PRODUCT / PROCESS CHANGE NOTIFICATION

PCN-000711

Add Carsem Ipoh to support production Assembly & Final Test)

PCN No. 000711
Qualification of Carsem Ipoh for TS3001X-M0XXQFNR products

Lead frame Outline

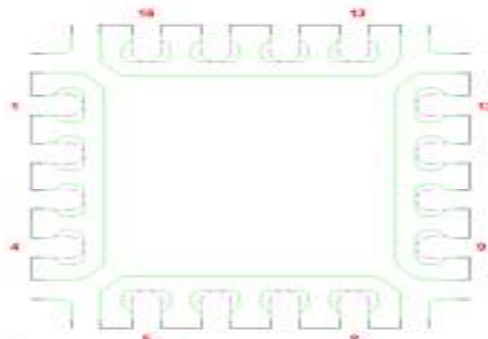
Lead frame outline Comparison CARSEMSZ (OLD) Vs CARSEMIPH(NEW)

No Difference on lead frame outline for CARSEMSZ and CARSEMIPH as both are using the same lead frame.

**Bonding Layout (CarsemSZ vs
CarsemIPH)**

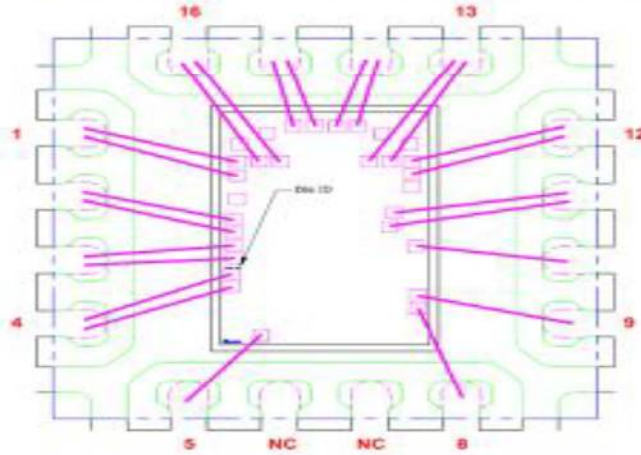
No Change in Bonding Layout.
